III. Revisions, Clarifications, and Corrections to the Draft EIR

This section of the Final EIR provides changes to the Draft EIR that have been made to revise, clarify, or correct the environmental impact analysis for the 5420 Sunset Project (Project). Such changes are a result of public and agency comments received in response to the Draft EIR and/or additional information that has become available since publication of the Draft EIR. The changes described in this section do not result in the Project creating any new or increased significant environmental impacts.

Revised Figure II-4
Conceptual Site Plan—Ground Level and P1 Level

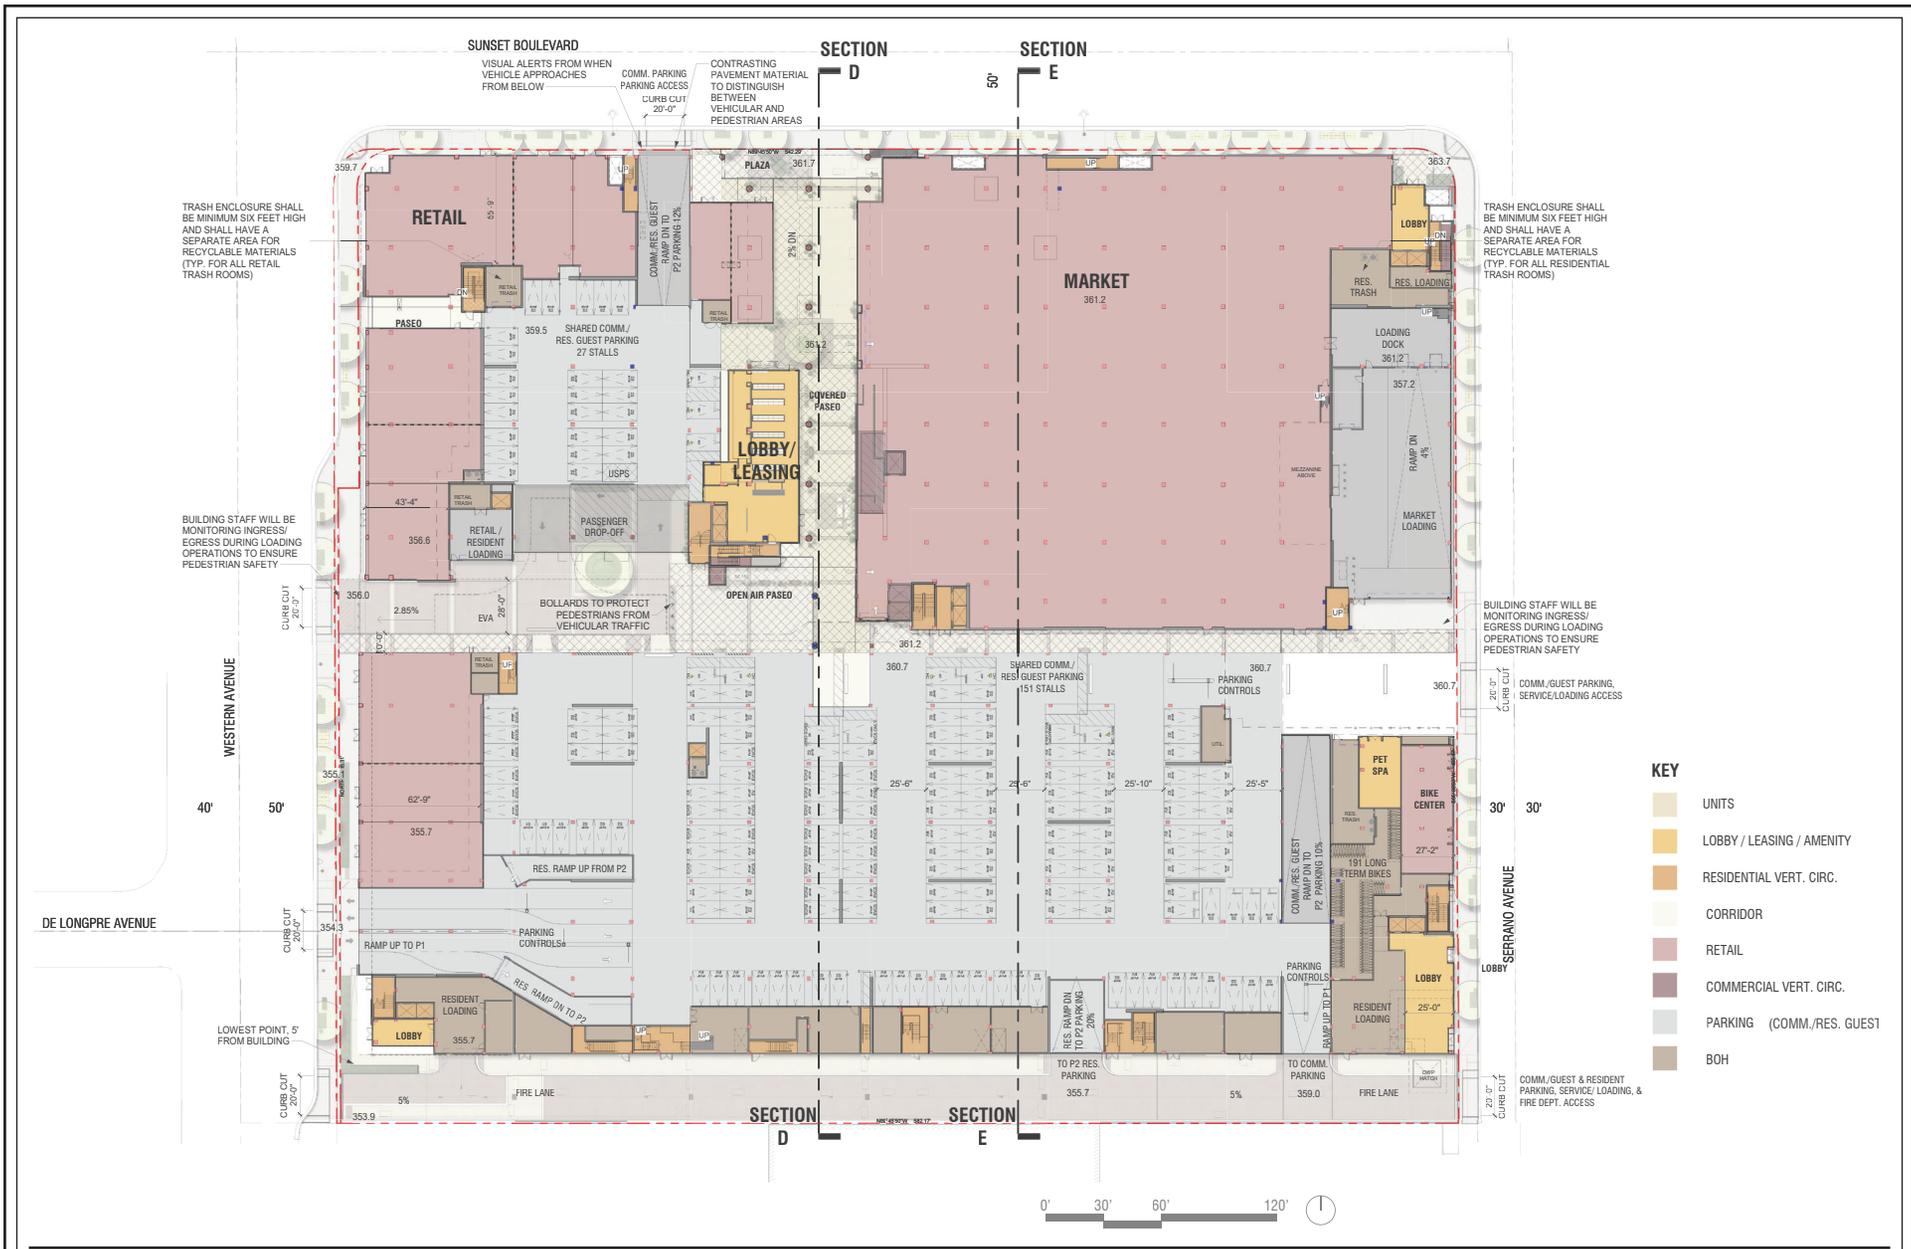
As shown in Revised Figure II-4 on page II-6, III-13 of the Final EIR, at the ground level, the four buildings would be organized around a publicly accessible ~~outdoor~~ covered pedestrian paseo that would run north-south through the center of the Project Site and a ~~driveway~~ pedestrian throughway that would run east-west through the center of the Project Site, as well as providing access for commercial/service—the residential, retail, and market loading and fire department access areas, as well as a passenger drop-off.

Section II, Project Description, page II-11, replace Figure II-4 with Revised Figure II-4 on page III-13.

Revised Figure II-5
Conceptual Site Plan—2nd Level Floor Plan (Lower Podium Level)

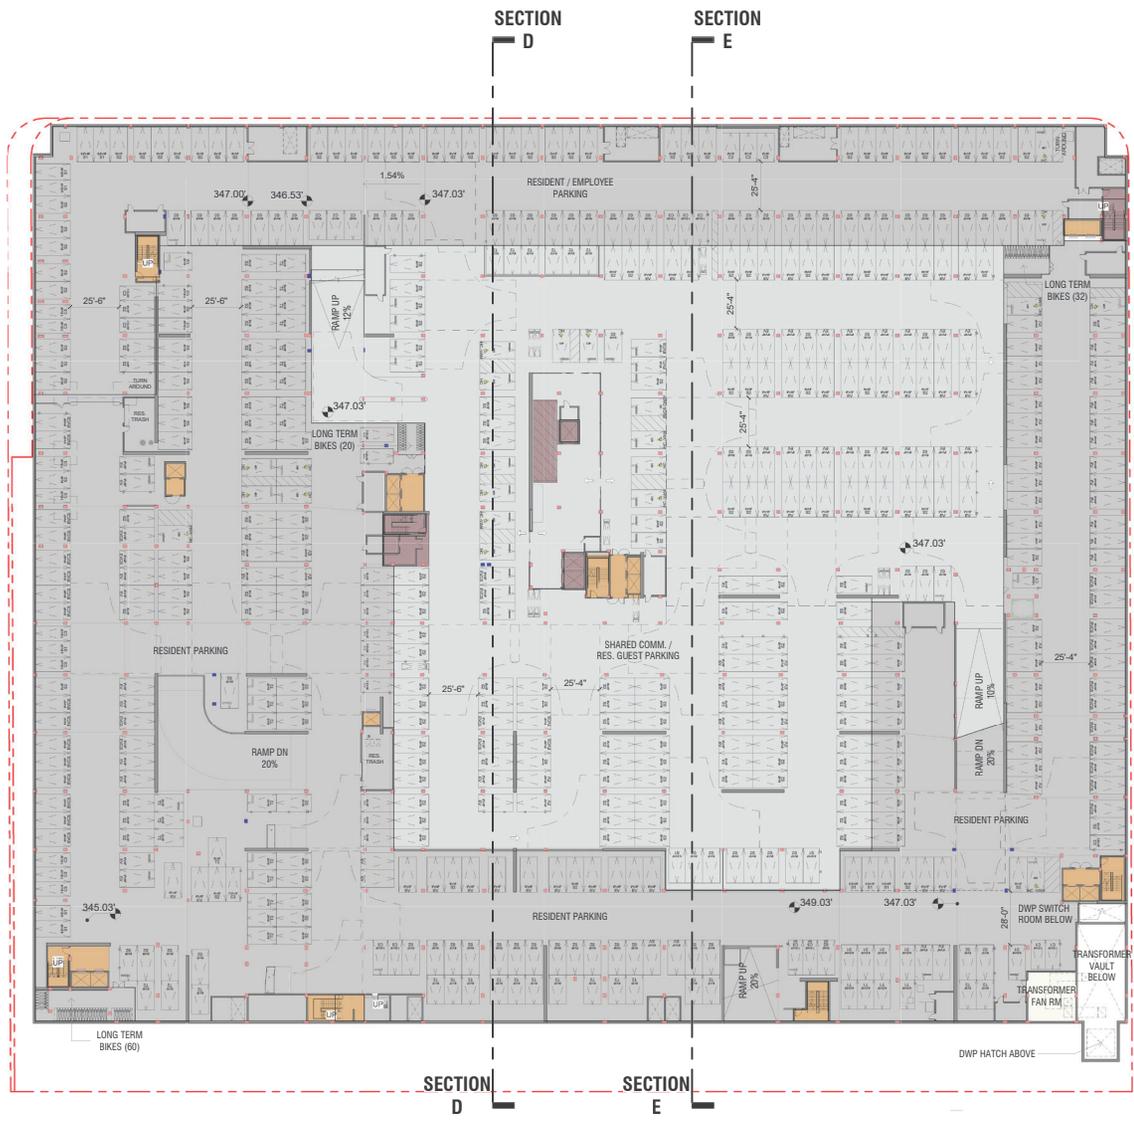
Section II, Project Description, page II-12, replace Figure II-5 with Revised Figure II-5 on page III-14.

Revised Figure II-7
Conceptual Site Plan—P2 Level

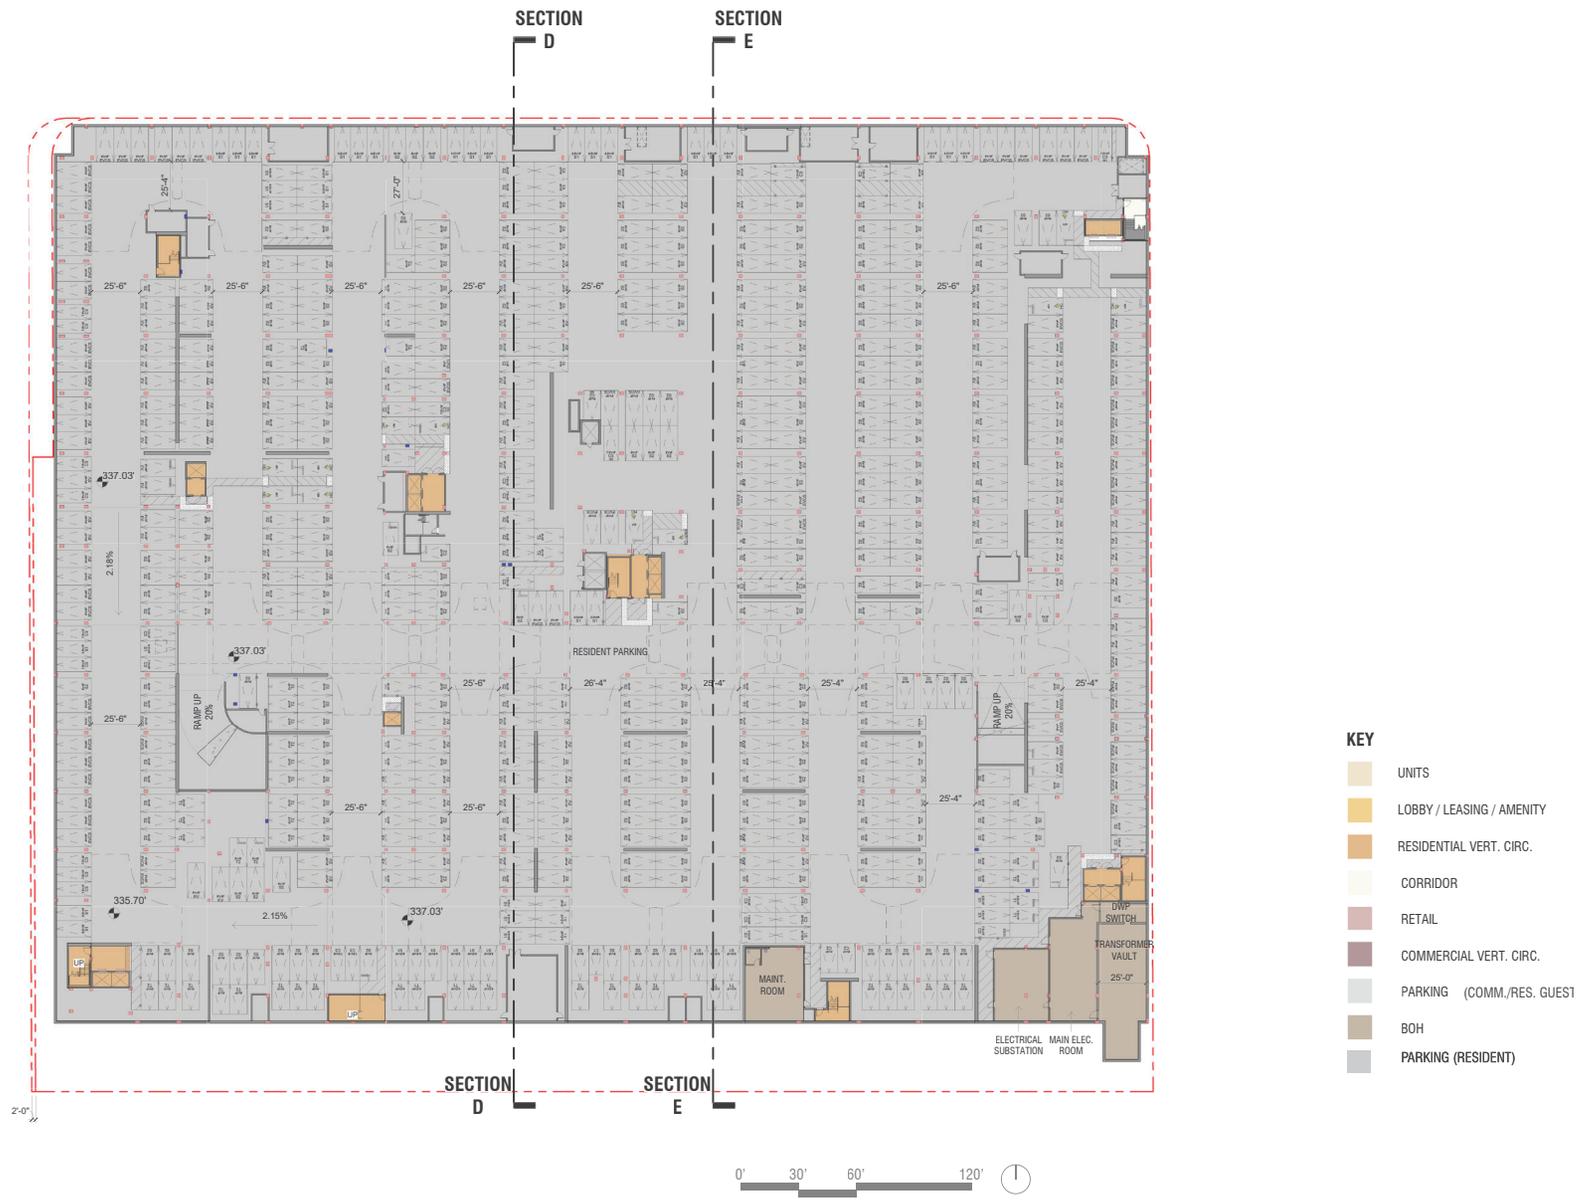
Section II, Project Description, page II-14, replace Figure II-7 with Revised Figure II-7 on page III-16.

Revised Figure II-10
Conceptual Building Elevations

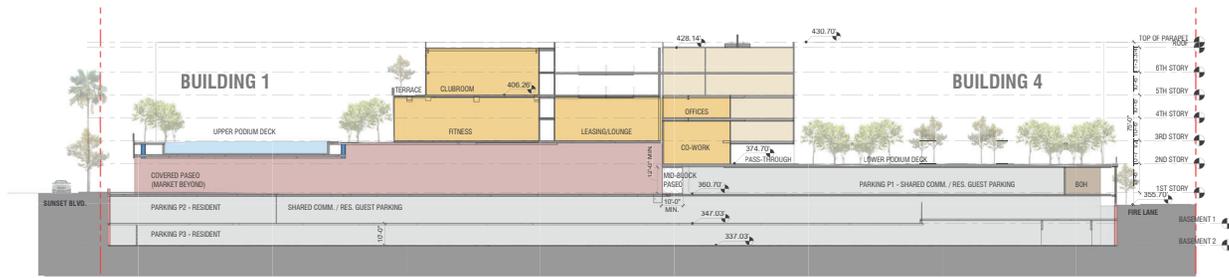
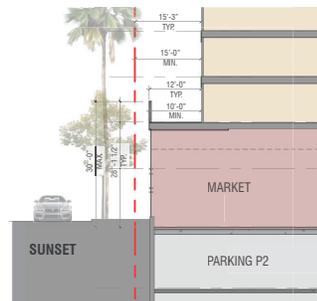
Section II, Project Description, page II-17, replace Figure II-10 with Revised Figure II-10 on page III-19.

Revised Figure II-11
Conceptual Landscape Plan-Ground Level Streetscape

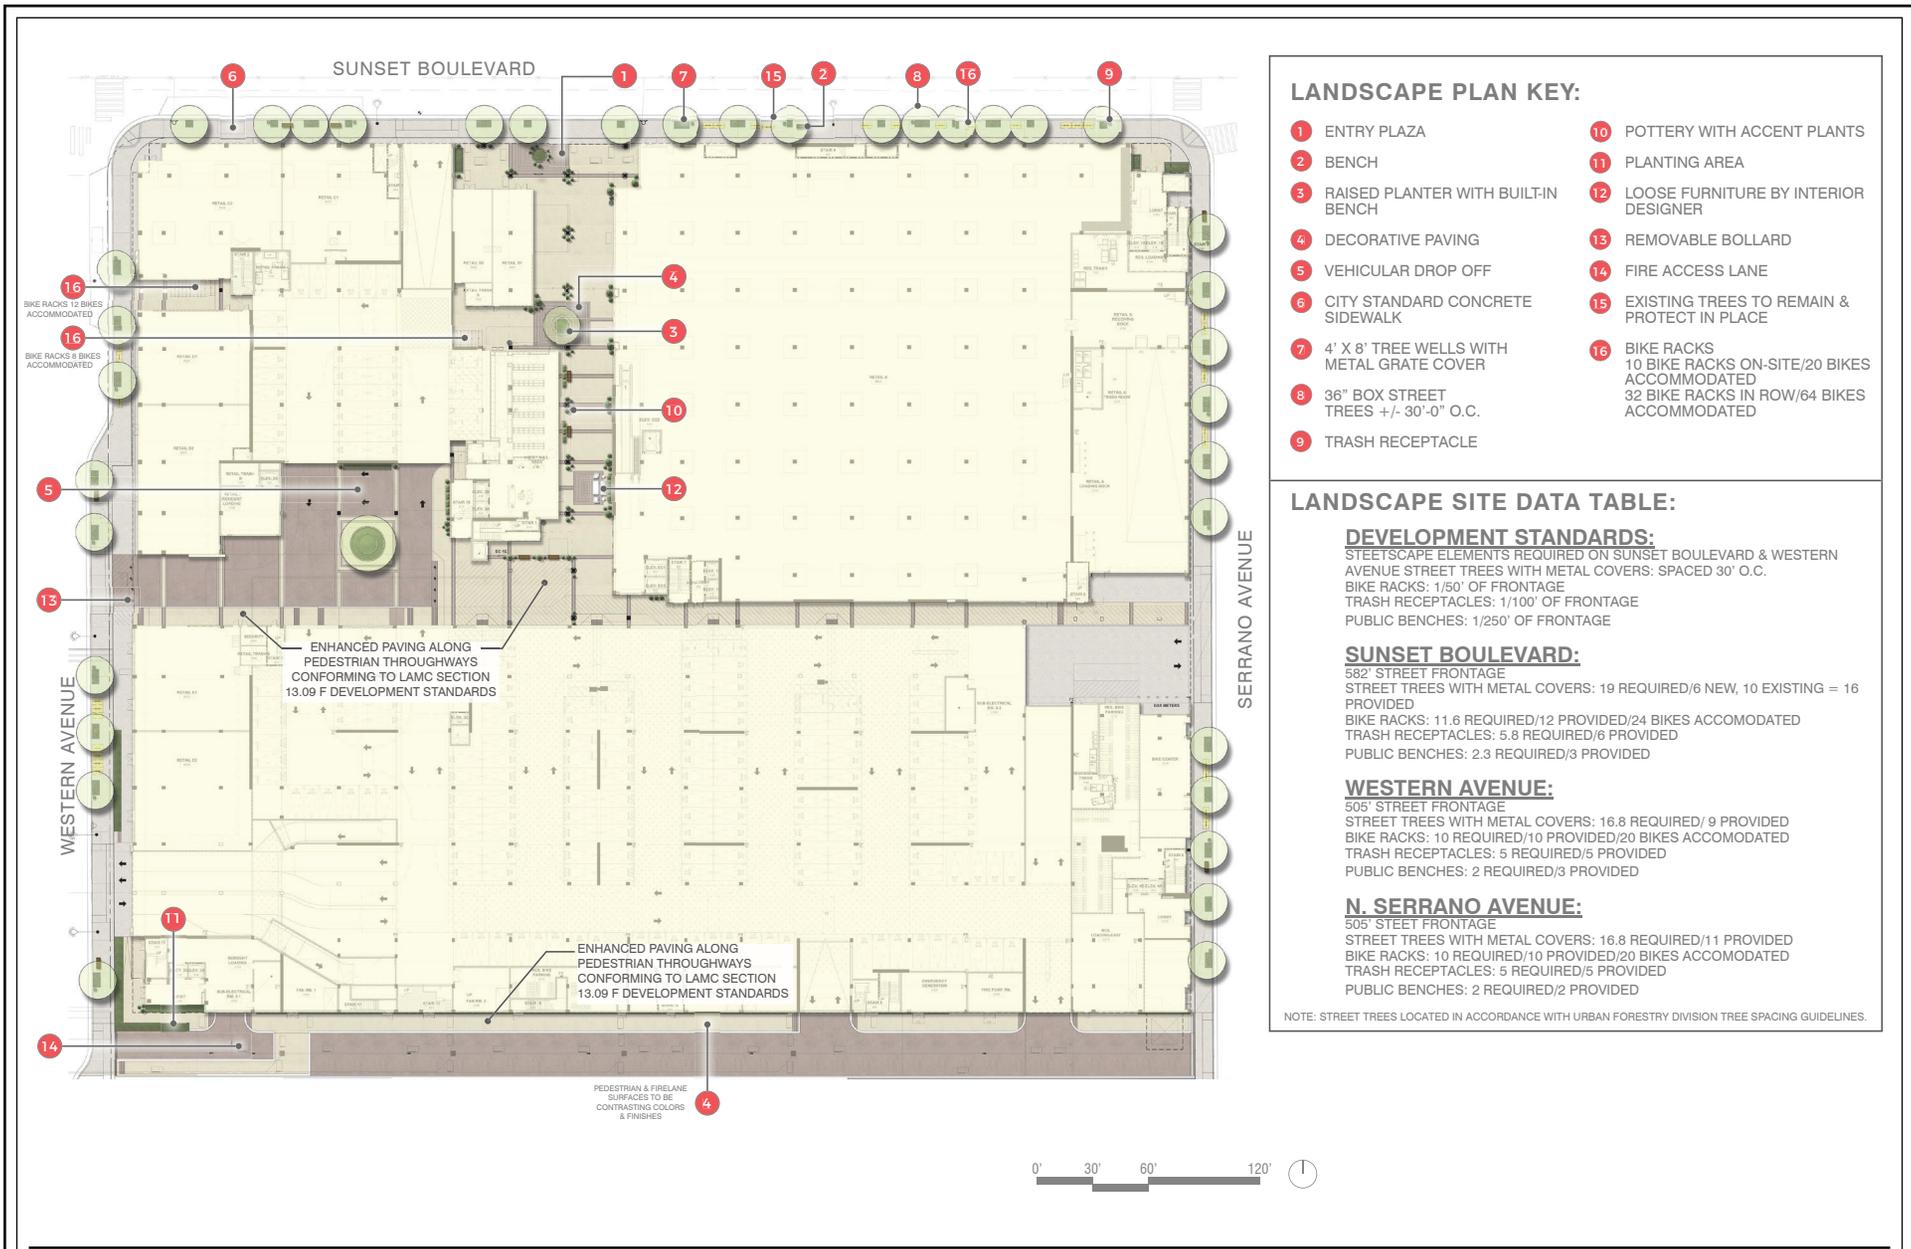
The Project includes ~~47~~ nine new street trees along Western Avenue, ~~nine~~ six new street trees along Sunset Boulevard plus retention of ~~44~~ 10 existing ~~Palm palm~~ trees, and ~~40~~ 11 new street trees along Serrano Avenue, exceeding the 1:1 ratio.

Section II, Project Description, page II-20, replace Figure II-11, Pool Courtyard (Buildings 1 and 2), with Revised Figure II-11, Conceptual Landscape Plan—Ground Level Streetscape, on page III-23.

Revised Figure II-13
Conceptual Landscape Plan—Level 3 Pool and Courtyards

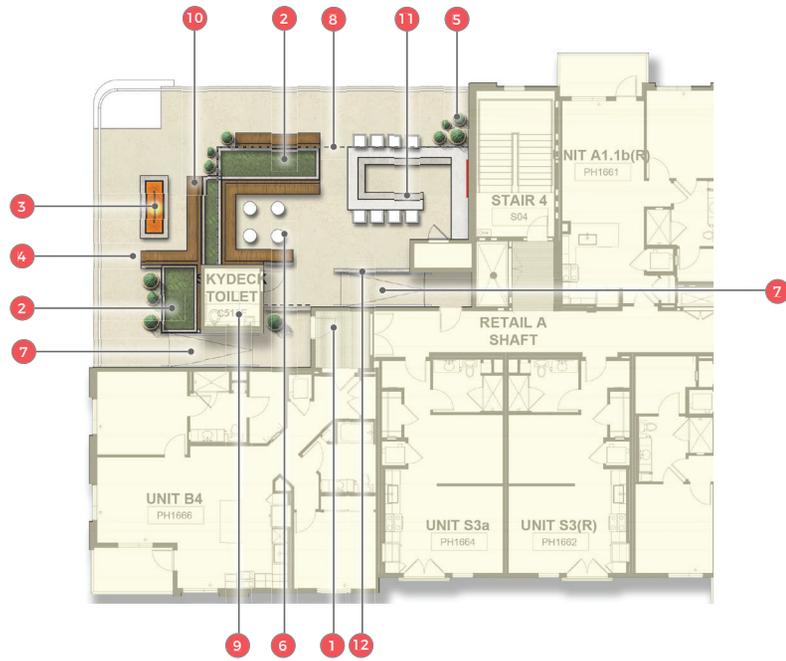
Section II, Project Description, page II-22, replace Figure II-13, Roof Terrace, with Revised Figure II-13, Conceptual Landscape Plan—Level 3 Pool and Courtyards, on page III-25.
